## Cherry BX-2 Supplement # 6

### Modification of the aileron-controls - drawing D 078

## Cherry BX-2 Supplement # 6 (page 2)

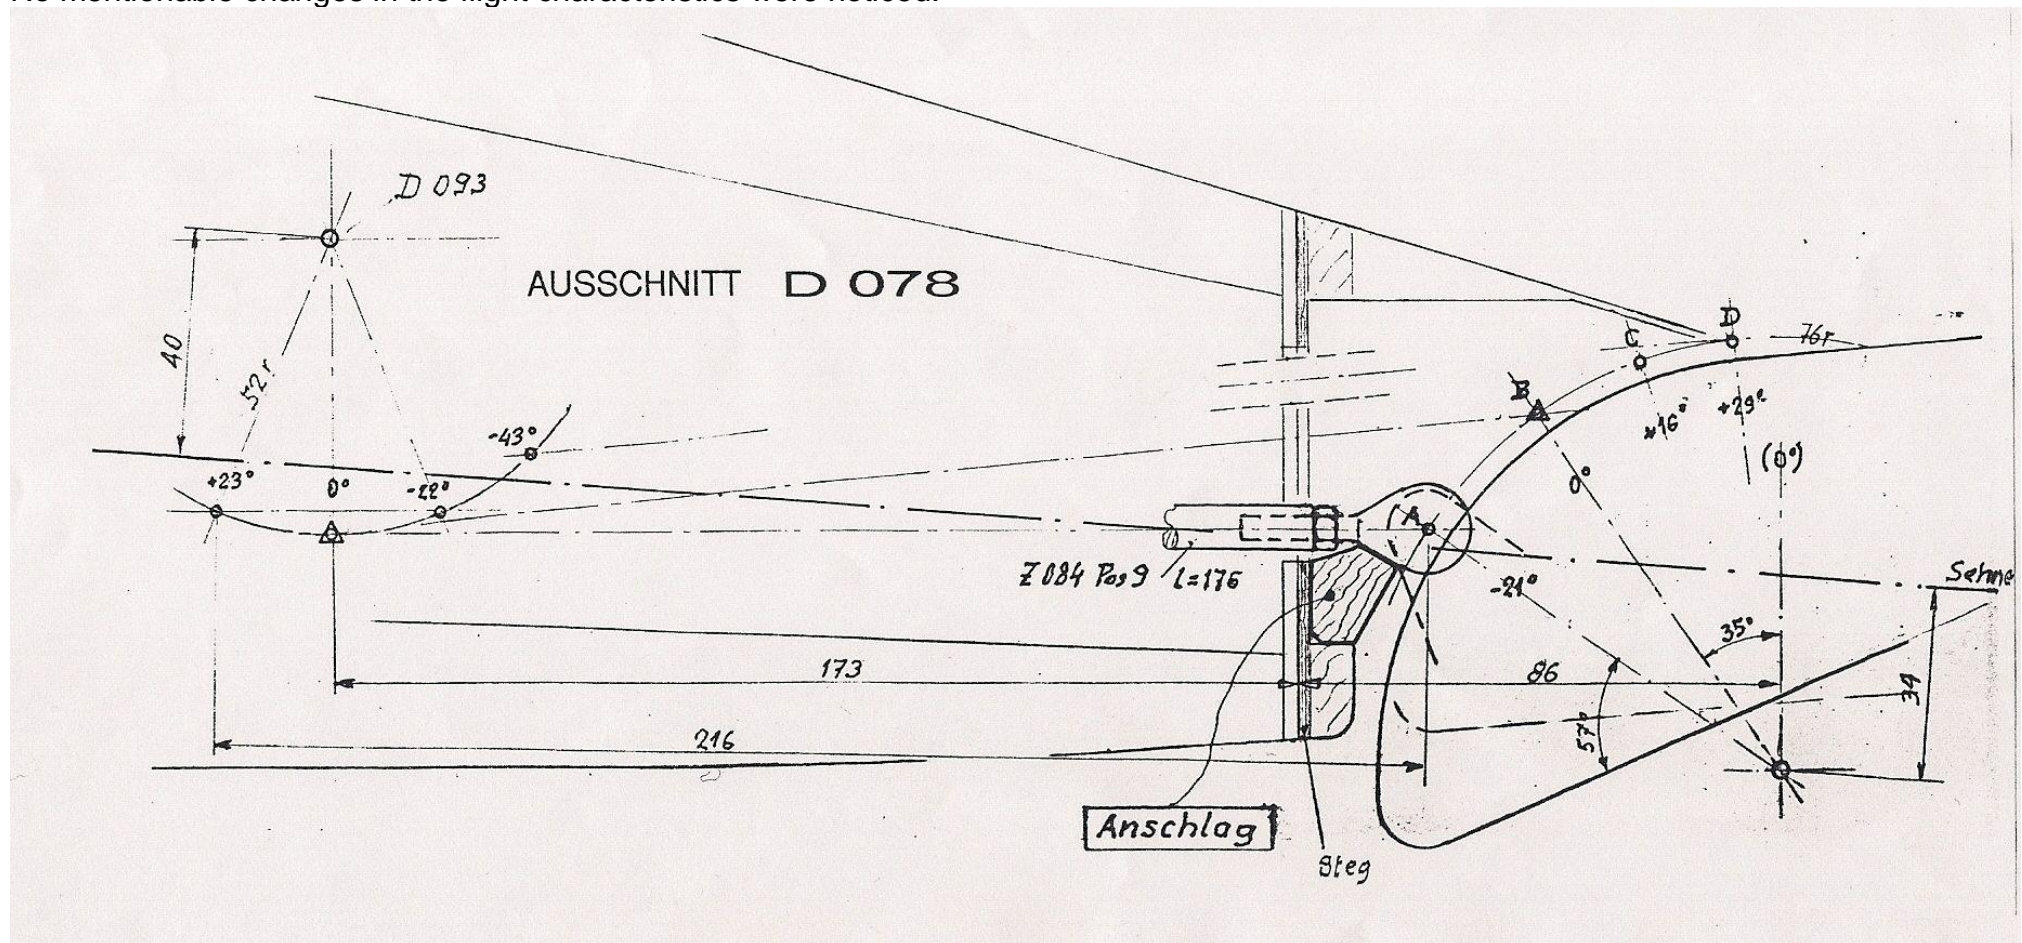
A mechanical stop "Anschlag" made of phenol-sheet or hardwood will be fitted and glued on the lower part of the rear wing spar (see attached drawing), limiting the upper Aileron movement to  $21^{\circ}$  (+/-  $2^{\circ}$ ). The stop limits the bearing of the push-rod. Additionally, the stops of the controls underneath the seat get beefed up in order to limit and synchronize both stops on each side (Z 075, "Ausschnitt"). The control mechanism itself will not be changed but the movement (ankle) will be slightly reduced. The new ankle-values for the aileron movement are given in the attached part-drawing D 078 mod. There are no changes to the flight characteristics.

D 078 mod. Querruder - Anschläge

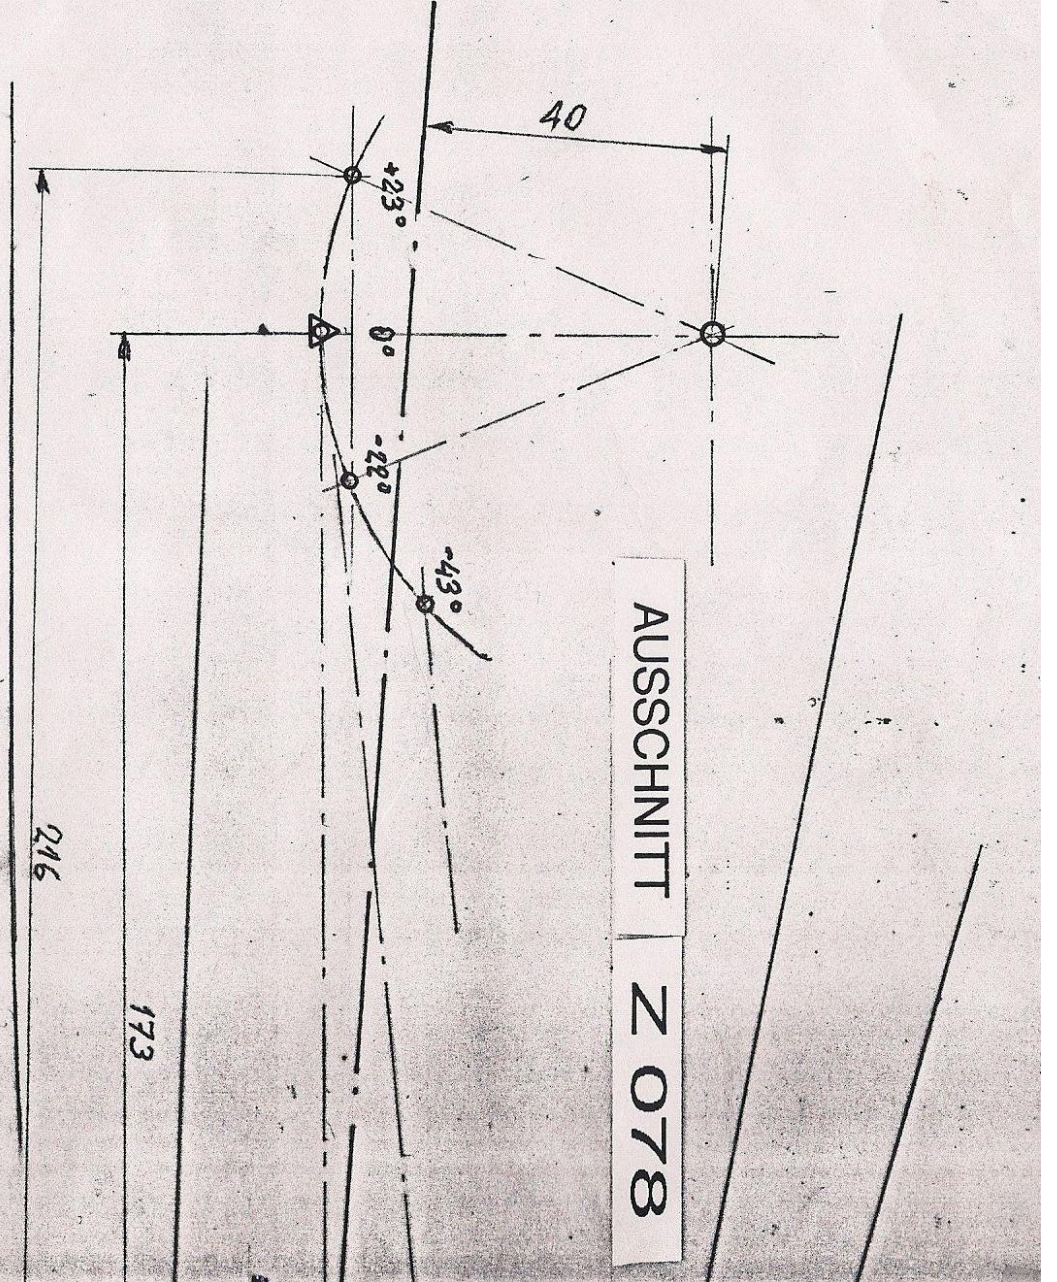
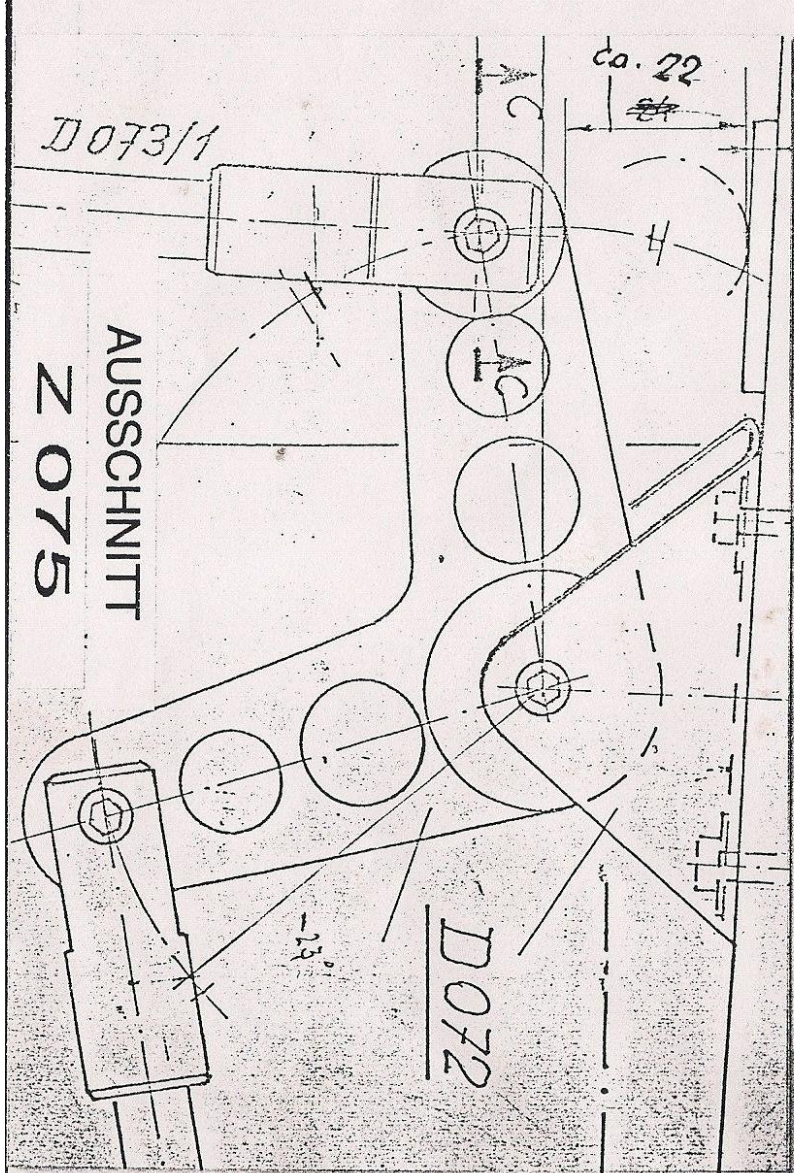
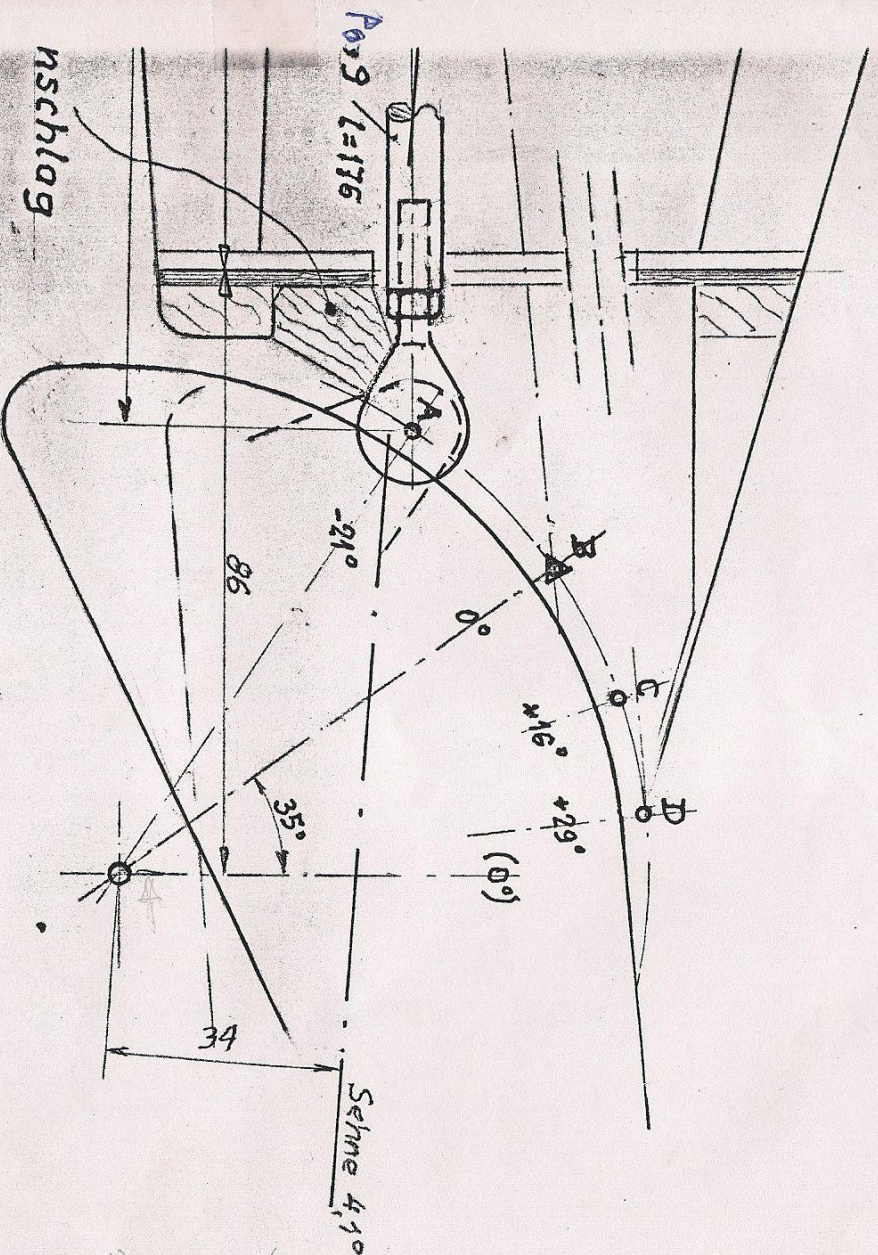
Die Ausschlagwinkel sind leicht reduziert wie folgt:

Pos. A	Flap 0°	QR nach oben	- 21°
Pos. B	Flap 0°	QR neutral	0°
Pos. C	Flap 0°	QR nach unten	+ 16°
Pos. D	Flap 60°	QR nach unten	+ 29°

ZWECK : Begrenzung des Querruder- Ausschlages

Querruder nach Modifikation D 078 mod. (Mai 2004)  
(bei Antrieb gemessen, Höhenruder neutral)

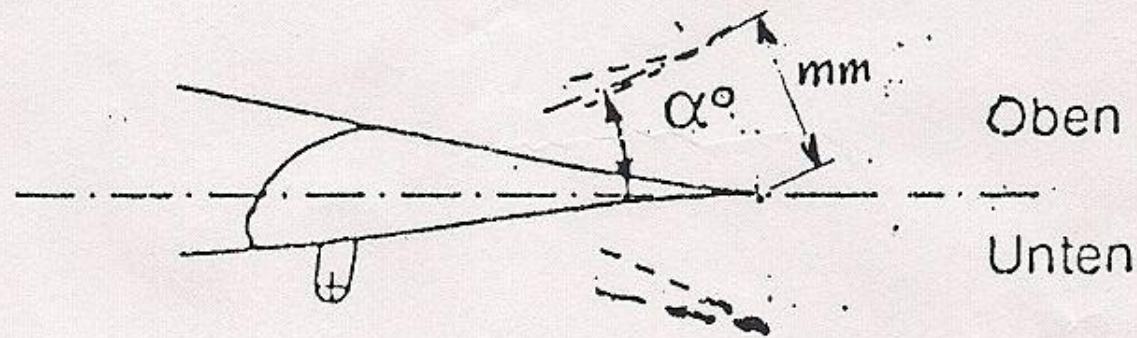
QR	Flap 0°		20°		40°		60°	
	α°	mm	α°	mm	α°	mm	α°	mm
noch oben	- 21	80			- 8	30	-3	12
nach unten	+ 16	60			+ 24	125	+29	142
